**Exponent "Protocol for Evidence" Rev. A; Figure 1 "Reported Location of Charges"**

CPUC 7/15/14

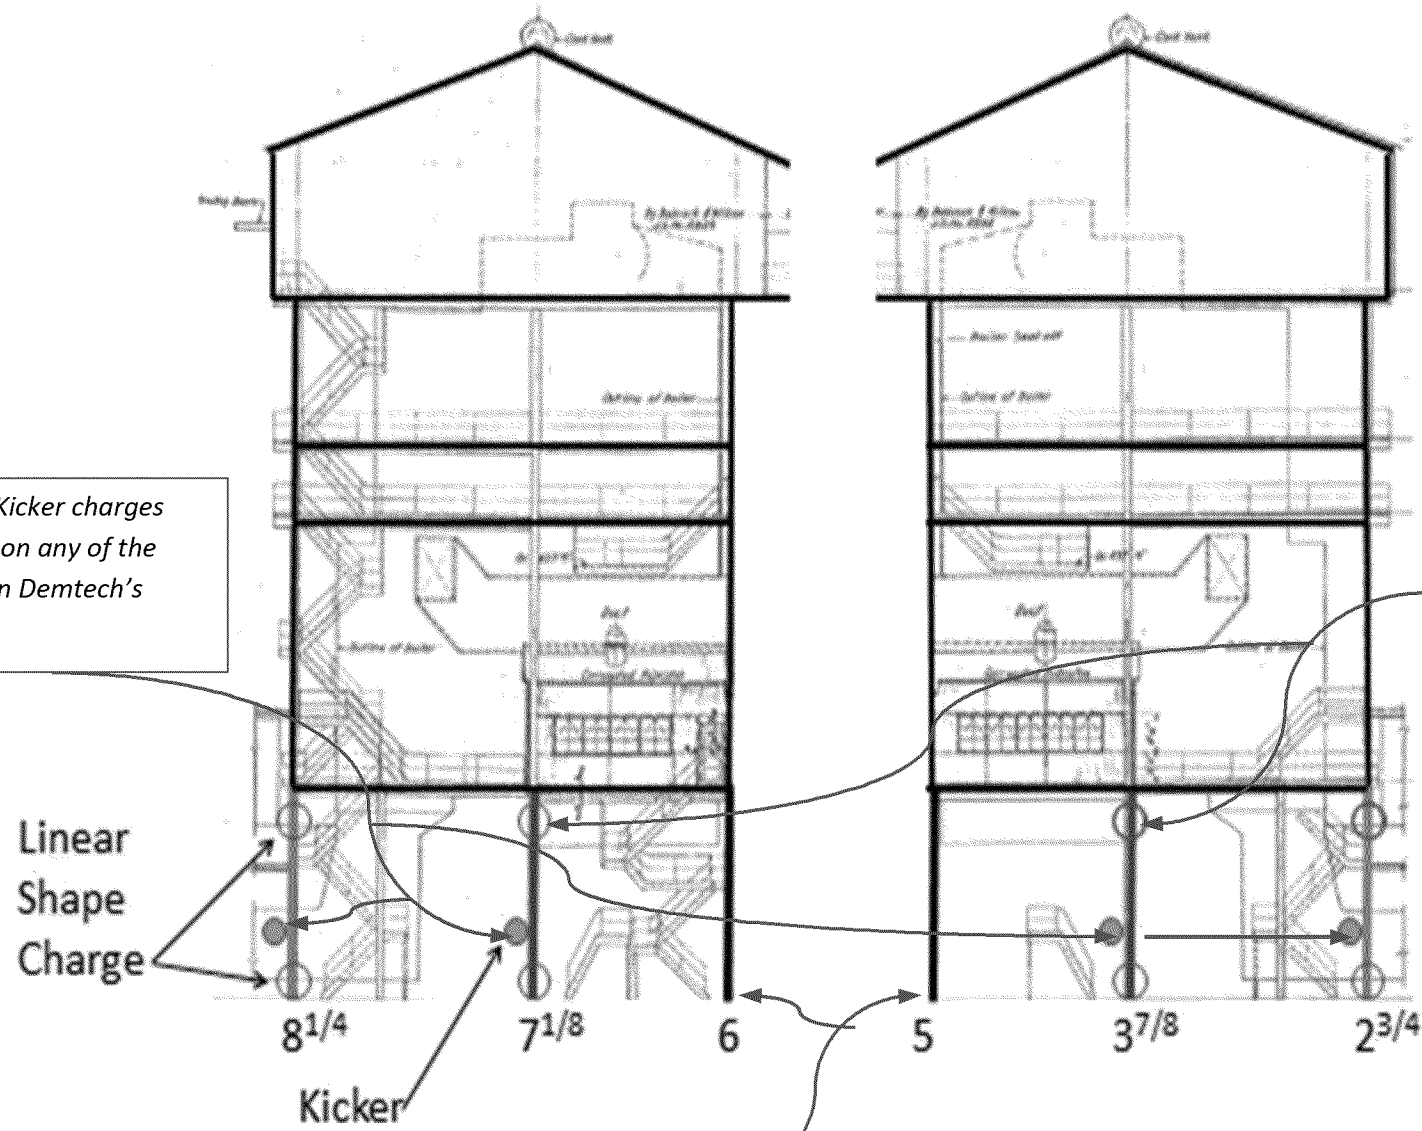
*CPUC Comment: Kicker charges are not indicated on any of the columns shown on Demtech's Demo Diagram*

*CPUC Comment: The location of the upper LSC on columns 7-1/8 and 3-7/8 (second row) are shown at the middle (lower) elevation on Demtech's Demo Diagram.*

*CPUC Comment; An LSC is not shown on column's 5 & 6 of this diagram (third row). However, it is shown at the base of these columns on Demtech's Demo Diagram.*
